STAFF REPORT

To: Downtown Commission
Downtown Master Plan Advisory Committee

Date: February 2, 2009

Subject: Height and Massing Implications of the Draft Downtown Master Plan

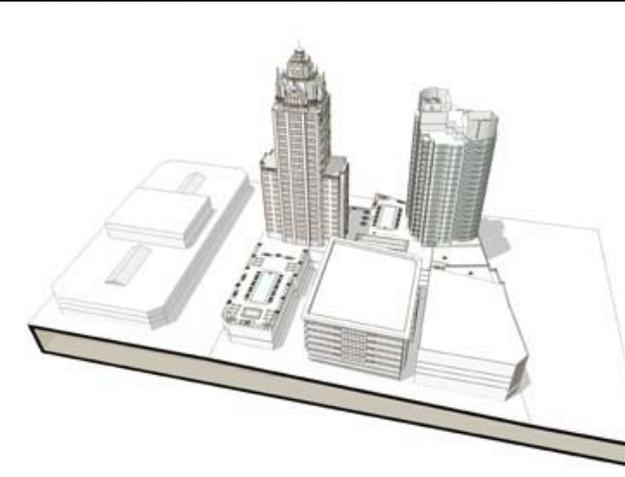
Requirement Ten: (Maximum Horizontal Dimension) For floors above the established street wall the maximum horizontal dimension in any direction is limited to 150 feet and is diminished by 2 feet for each subsequent floor to a dimension of 100'. The existing design should meet this requirement.

Requirement Eleven: (Shadow Impacts) Although no shadow study was required during the review of the Ellington there are no expected impacts on public open spaces. The north edge of the building is about 370' from the lower ends of Pack Square.
